**Change**

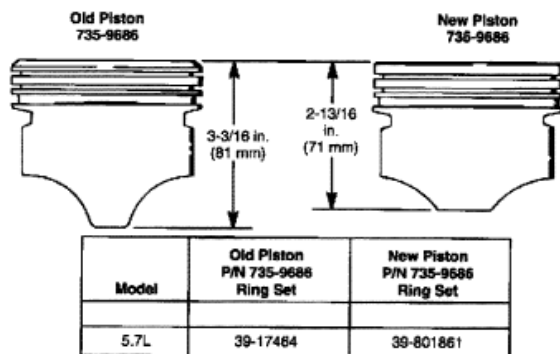
The latest replacement standard pistons (P/N 735-9686) for these engines use a different set of piston rings. The latest piston's oil ring groove is not as deep as the older piston.

The latest replacement piston will be shipped with a set of piston rings.

If piston rings only are required, refer to the drawings before ordering replacement piston ring sets from the chart.
